As an Interested Party (IP) we are grateful for the opportunity to provide comment by written response to the SoS BEIS’s letter dated 11<sup>th</sup> November 2021 (Reference A) for the re-determination of the Norfolk Vanguard windfarm project. We note the deadline for IPs to respond was subsequently extended to 23:59hrs on Friday 19<sup>th</sup> November 2021.

Project: **Norfolk Boroas** Report: **Environmental Statement**

**Scenario 1**  
**Zone of Theoretical Visibility**  
**Onshore Project Substation**

Figure: 29.5 Drawing No: PS6640-006-029-005

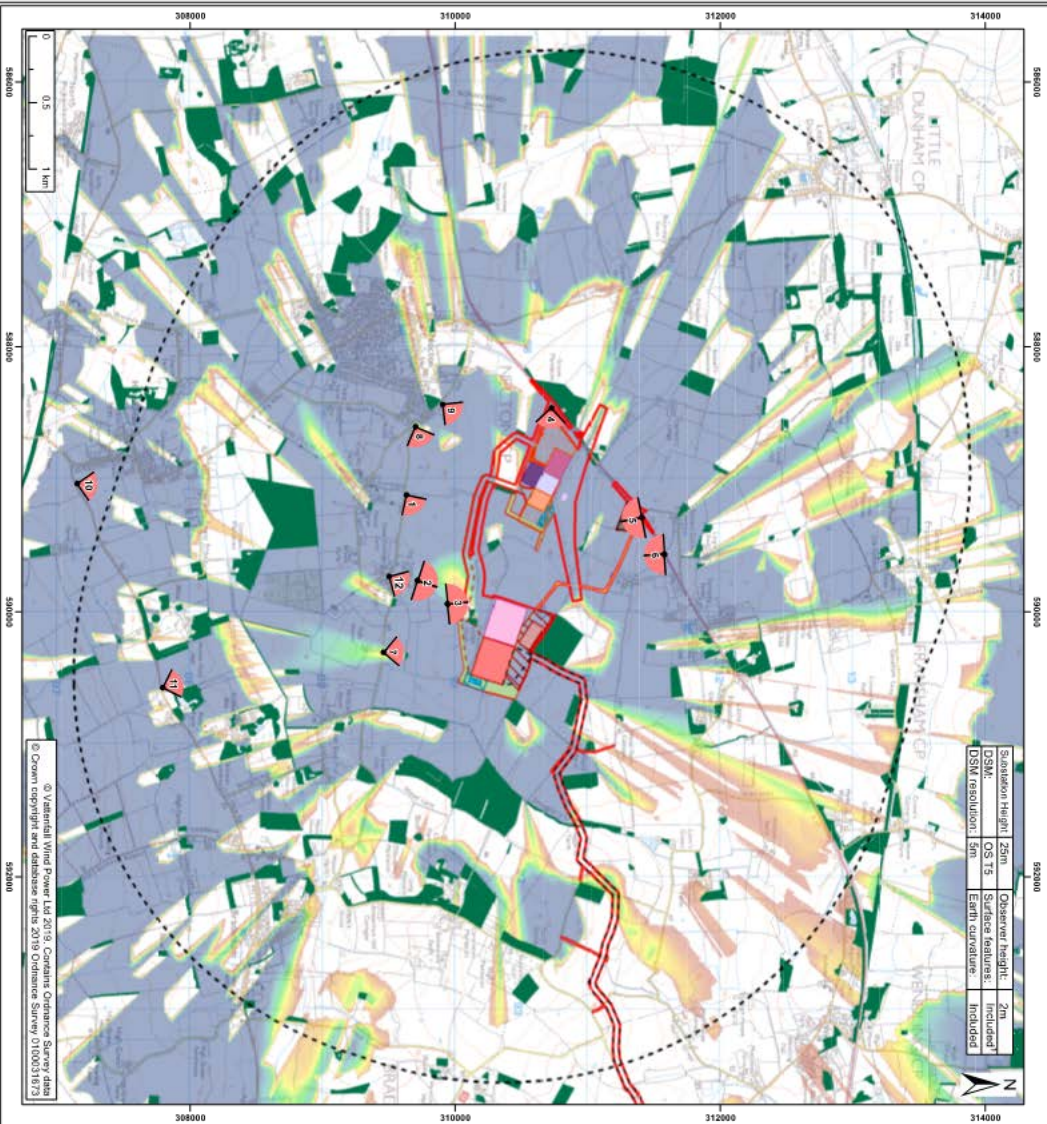
The visual impacts of the proposed substation complex are **not localised** as is clear in the graphic at Reference F, which was submitted by the Developer in the ES. Furthermore, there is no question whatsoever that the substation would not be seen from many kilometres away. To put the size of the development into context, the impacted area of land the substation would be built on, according to the graphic, is approximately twice that of the whole village of Necton. To be clear, the substation infrastructure, if it were consented, would dominate the rural landscape.

- It is our contention that an **Independent Design Review** (IDR) of the proposed substation complex is required before any consent for either Vanguard or Boreas could be granted; we will address the subject of an IDR by separate response.
- **LVIA Viewpoints (VPs).** Please see Reference F for the Viewpoints (VPs) referred to by the Applicant. The VPs are all within the zone of “Higher Theoretical Visibility” and we contend it would be impossible to visually screen the four 19m tall buildings from any of the VPs.

We further contend that the LVIA effects are **not localised** and would be visible from a considerable distance away from the proposed substation. Doubling the size of the complex will obviously double this impact.
